UNITED STATES  
DEPARTMENT OF THE INTERIOR  
BUREAU OF LAND MANAGEMENT  
OCD ArtesiaFORM APPROVED  
OMB No. 1004-0137  
Expires: July 31, 2010**SUNDRY NOTICES AND REPORTS ON WELLS**  
**Do not use this form for proposals to drill or to re-enter an abandoned well. Use Form 3160-3 (APD) for such proposals.**5. Lease Serial No.  
NMNM81616

8. Well Name and No.  
H B 10 Federal #59. API Well No.  
30-015-33836

**PROPOSED PUG & ABANDONMENT**

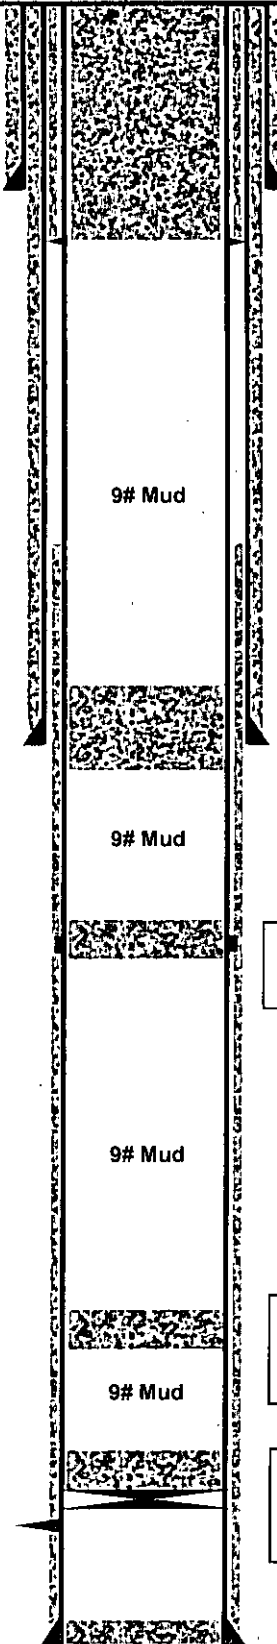
Proposed:  
 3. Cut wellhead off. Set dry hole marker.  
 2. Pump 195 sx CI C in/out to surface.  
 1. Perf csg @ 822' **882**  
 (T.Salt @ 832'; shoe @ 419')

Proposed:  
 1. Spot 25 sx (250') CI C @ 4,090' - 3,840'. **Tag**

Proposed: **7325 - 7075**  
 1. Spot 25 sx (250') CI C @ 7,280' - 7,030'.  
 (Bone Spring @ 7,270')

Proposed: **7875-7625**  
 2. Spot 25 sx (200') CI H @ 7,900' - 7,780'. Tag.  
 1. Set CIBP @ 7,900'.  
**7875**
